**MAINE TURNPIKE AUTHORITY**

**ADDENDUM NO. 1**

**CONTRACT 2024.15**

**VARIABLE MESSAGE SIGN AND WALKWAY REPLACEMENT**  
**NORTHBOUND MAINLINE MILE MARKER 30.35 &**  
**SOUTHBOUND MILE MARKER 47.7**

PROJECT:			
TITLE: SITE RISER, 1 VF-2X20, VFC IN TC			
DATE: 17 JUL 17	DIM UNITS: INCHES [MILLIMETERS]	SHEET	REV 02
SCALE: NONE	DO NOT SCALE DRAWING		
DESIGN: ASHANKS	JOB NO. P1993	FUNC - TYPE - SIZE F - 10 - B	3686201
DRAWN: ASHANKS

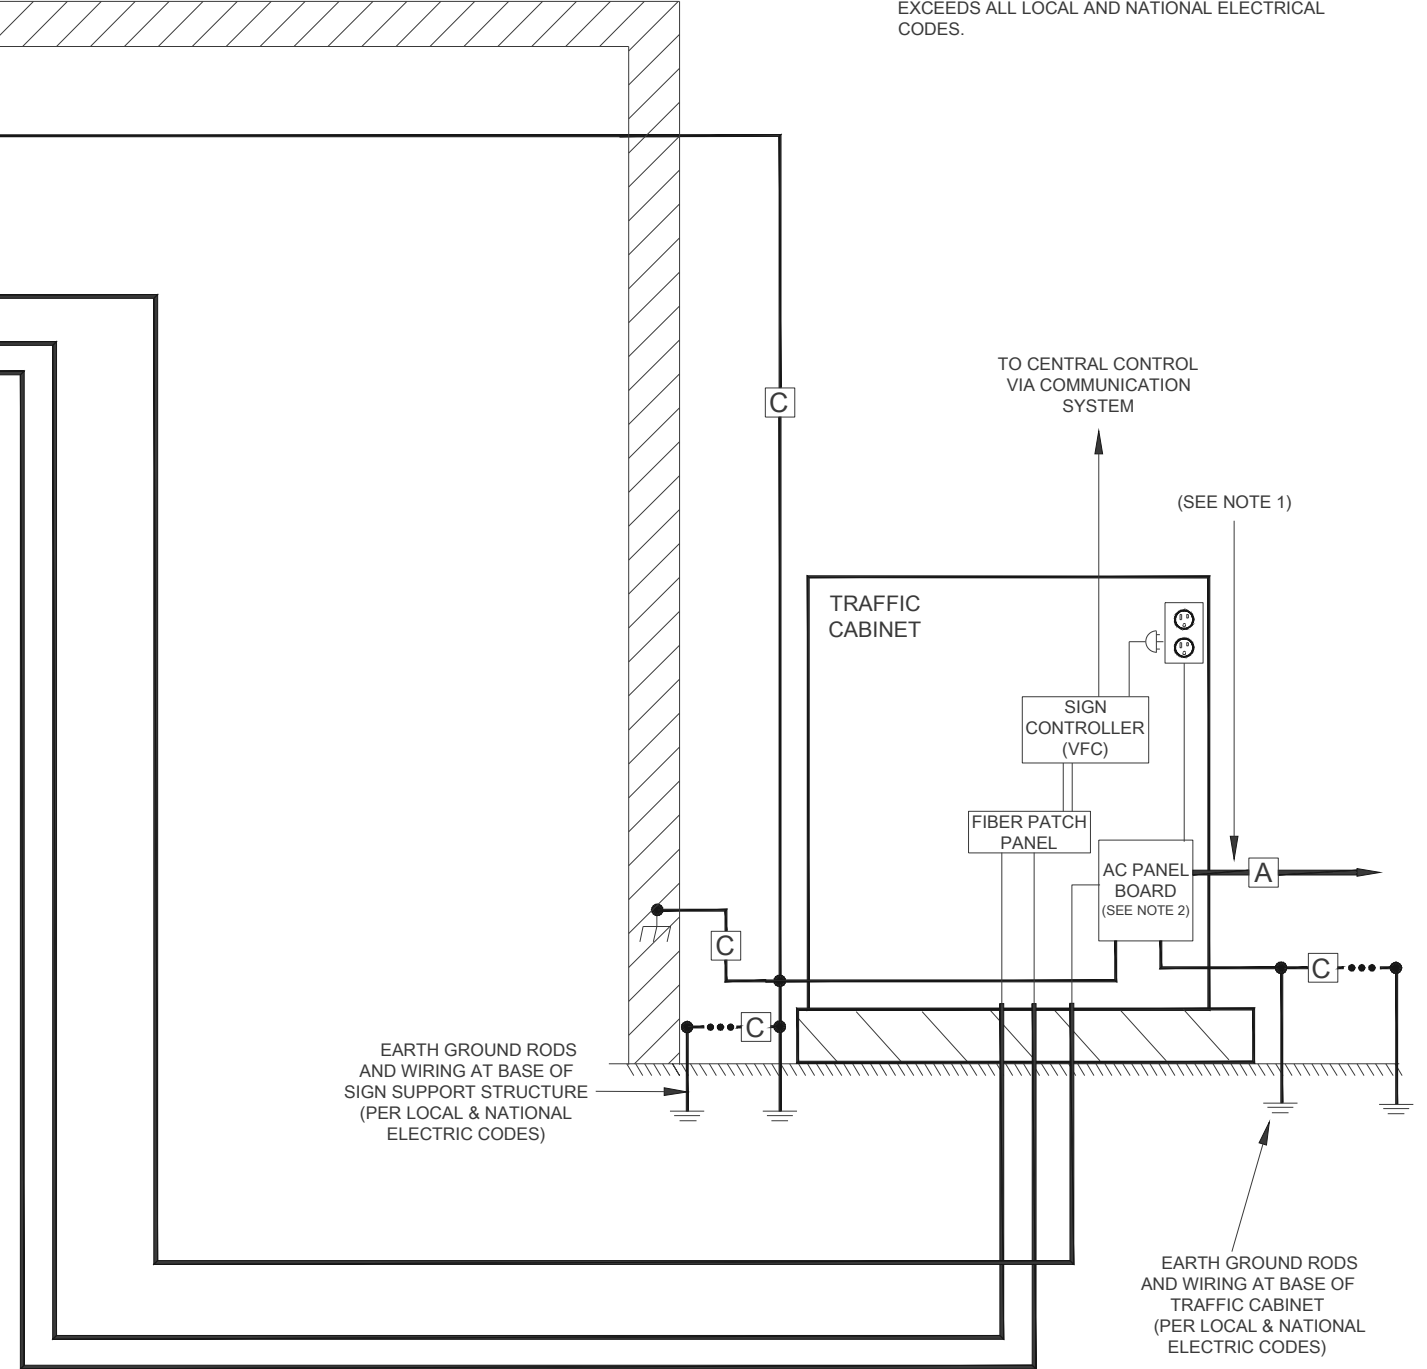
- Add the attached Daktronics wiring diagram to Appendix A

Question 1: I see no wiring diagrams with any detail such as a 1-line diagram.

Question 2: Per the spec, it appears that they want (2) 3" for Power and (2) 3" for Comm. However, it does not state what they are requiring for wire.

Answer: See attached Daktronics wiring diagram.

Answer: For power, the electrical circuit from the cabinet to the sign, a 2-pole 50 amp breaker is provided for powering the sign. The wire shall be AWG XHHW-2 sized appropriately per code. For communication, see attached wiring diagram for fiber optic cable information.
